Thank you for your letter and for the reviewers' comments concerning our manuscript entitled "A Multi-strategy-mode-waterlogging-prediction Framework for Urban Flood Depth" (ID: nhess-2022-36). Those comments are all valuable and very helpful for revising and improving our paper, as well as the important guiding significance to our research. We have studied comments carefully and have made the correction which we hope meet with approval. The main corrections in the manuscript and the responses to the reviewer' s comments are as flowing:

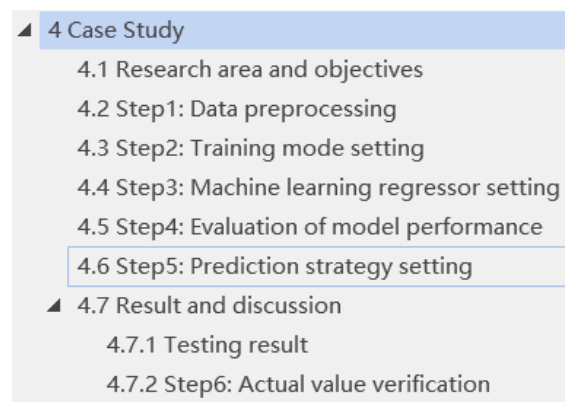
**Comment RC#1-1: A flowchart is necessary for the case study as well, as there have been many details regarding data extraction, preprocessing and comparison between methods, etc. in the case study.**

**Reply:** Your comment is constructive, and we believe that a flowchart would more clearly reflect the steps of the case study and allow for a more progressive approach to the results and conclusions. We have modified the case study sections according to the process steps in the framework and expressed them in flowchart form.

**Relevant changes:** In line 329 to 529, we rewrite the implementation process of the case study according to the workflow of the framework, conducting detailed experiments on the case from data integration to truth verification and discussing the results. We changed the structure as follows:
